SERVICE BULLETIN

INSPECTION AND REPAIR – STATION 142 TAIL ROTOR CONTROL BELLCRANK SUPPORTS, PN 369A3035–11 AND 369A3035–15

500D Model 369D Helicopter Serial Nos. 0003D through 0531D; 0533D, 0535D and 0537D

Figure 1. Installation of Doublers - Tail Rotor Control Bellcrank Supports

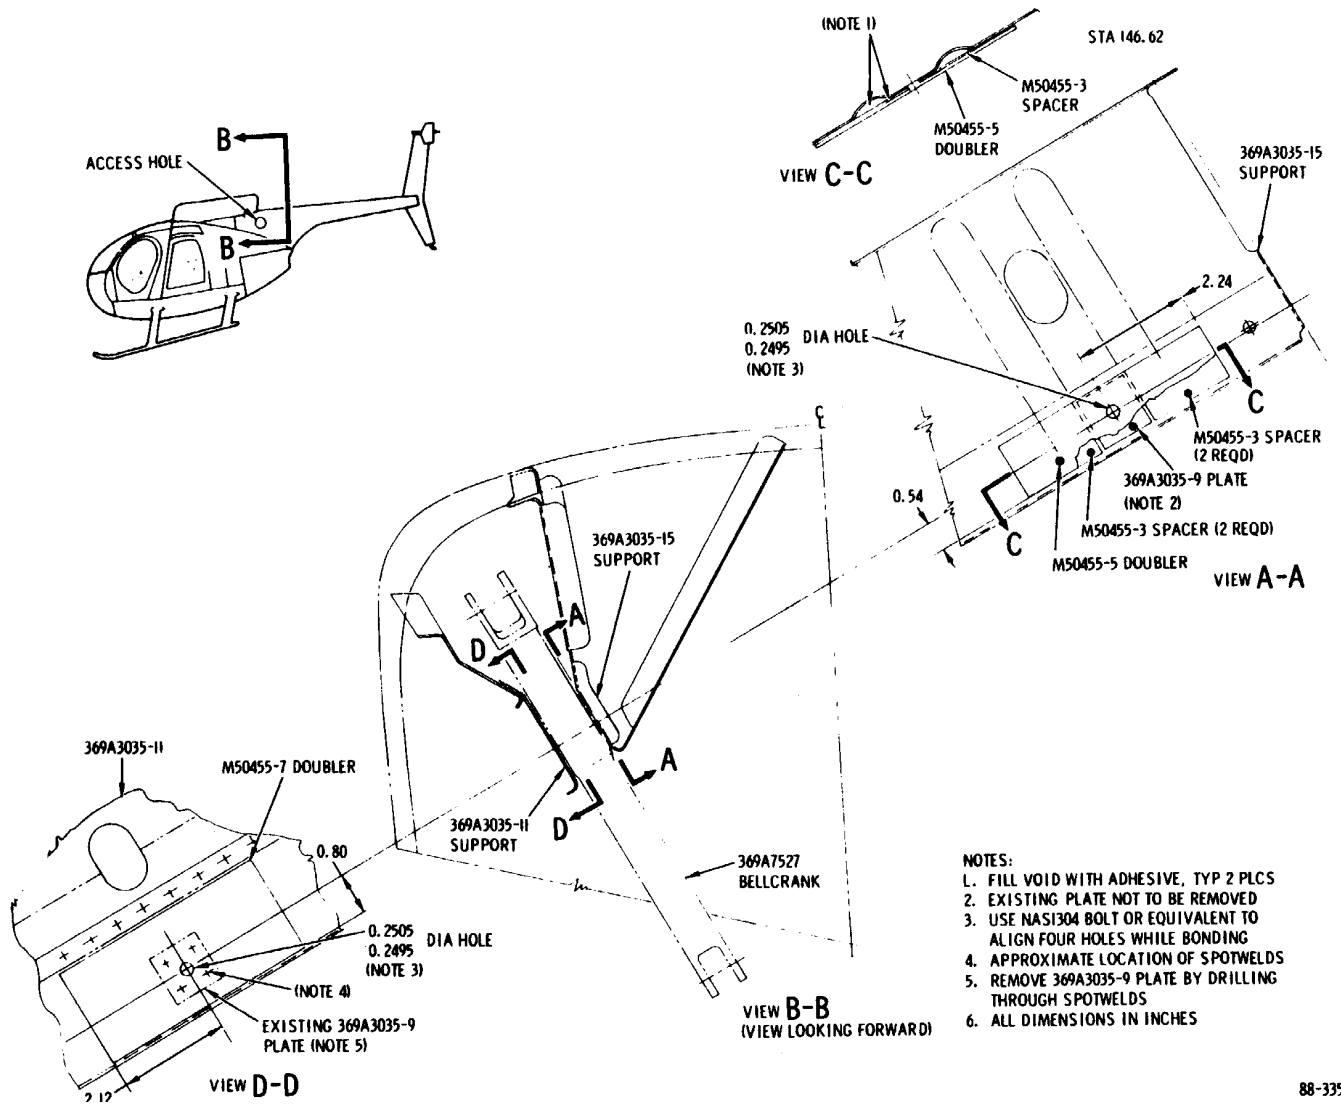
- (1). Remove Station 142- tail rotor control bellcrank assembly, per Section 8 of HMI-Vol-ume I.
- (2). Using bright light and mirror, visually inspect PN 369A3035-9 doublers on bellcrank supports for cracking or damage. (See Figure 1.) Pay particular attention to the four spot weld spots attaching doublers to supports.

- (1). As required, remove Station 142 Station tail rotor control bellcrank assembly, per Section 8 of HMI-Volume I.
- (2). Remove existing 369A3035-9 doubler from outboard 369A3035-11 bellcrank support, by drilling out doublet spotwelds, 4 places, as shown in Figure 1.

- Removal of 369A3035-9 doubler from inboard side of 369A3035-15 bellcrank support is not required.
 - Stop drill any crack or cracks found in 369A3035-11 and -15 bellcrank supports.
- (3). Lightly abrade laying surfaces of 369A3035-11 and -15 bellcrank supports; it is not necessary to abrade through paint to secure good bonding. If abrading removes paint and primer from supports, doublers and spacers must be bonded immediately after abrading.

- (4). Wipe laying surfaces of M50455-3 spacers, and M50455-5 and M-50455-7 doublers, with solvent; apply adhesive to laying surfaces.

- (5). Install spacers and doublers as shown in Figure 1. Use NAS1304 bolt or equivalent as alignment pin to align holes while bonding. Coat bolt or pin with bond releasing agent to prevent possible adhesion to structure.
- (6). Insert wood block, and metal shims as required, between bellcrank supports to press doublers against structure and prevent excessive adhesive build up. Slot wood block to provide relief for alignment pin. Wrap wood block and shims in waxed paper to prevent possible adhesion to structure.
- (7). Cure adhesive for 24 hours; remove wood block and shims from supports.
- (8). Reinstall Station 142 bellcrank per HMI-Volume I.
- (9). Record compliance with Part II of this Notice in Compliance Record of helicopter Log Book.

Figure 2. Field Fabrication of Bellcrank Support Doublers and Spacers

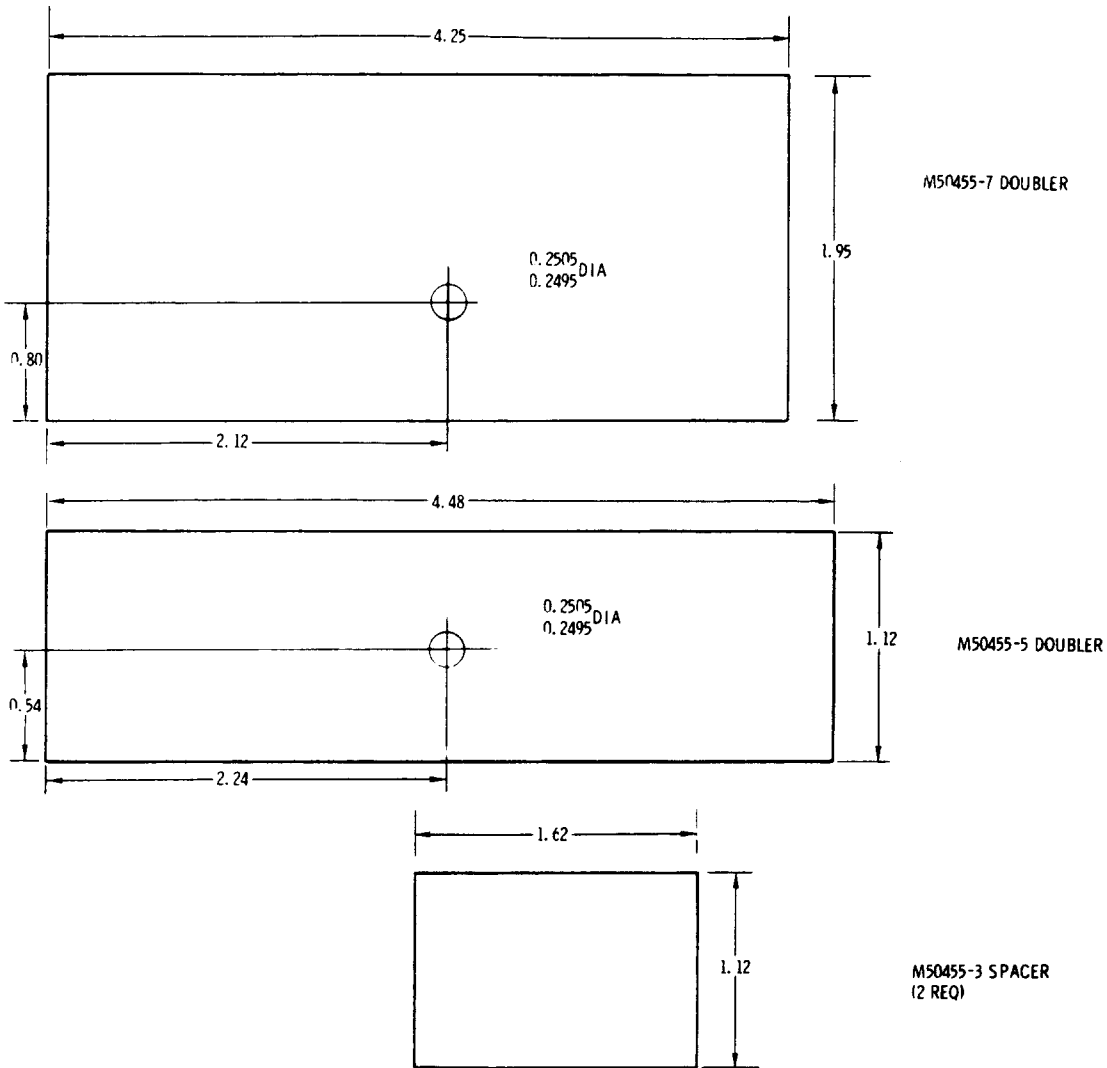
* May be field fabricated per Figure 2.

NOTE: Required doublers and spacers may be field fabricated and adhesive primed per Figure 2.

1. FABRICATE FROM ALALY SH 2024-T3, QQ-A-250/5 TEMP T3.
2. ALL DIMENSIONS IN INCHES.
3. COAT AND PRIME FAYING SURFACES AS FOLLOWS:
LIGHTLY ABRABE FAYING SURFACES WITH 180 GRIT PAPER AND WIPE CLEAN WITH M-114M SOLVENT. IMMEDIATELY APPLY CHEMICAL CONVERSION COATING (CHROMICOAT L-25 OR MIL-C-5541, CLASS 2) TO PRECLUDE OXIDE BUILD UP ON ABRABED SURFACES. BRUSH COAT LIQUID PRIMER (HYSOL EA9210) ON FAYING SURFACES ONE OR TWO HOURS AFTER CONVERSION COATING; AIR DRY FOR 30 MINUTES AT ROOM TEMPERATURE; OVEN CURE PRIMER FOR 60-65 MINUTES AT 250°F to 260°F.
